SERVICE INFORMATION BULLETIN

APPLICABILITY: 2017-2018MY Legacy
SUBJECT: Trunk Hinge Flange Bolt Change

NUMBER: 12-248-18
DATE: 08-09-18

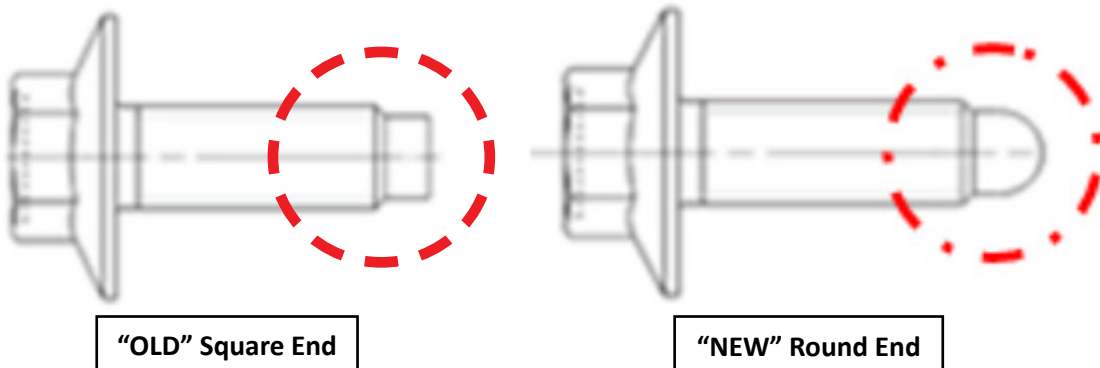
This Service Information bulletin announces a change made to the trunk hinge mounting bolts. The threaded end of the new flange bolts has been changed to a round type instead of square to prevent getting caught on items as they are loaded into and out of the trunk.

The part number for the new flange bolts is: **901000458**.
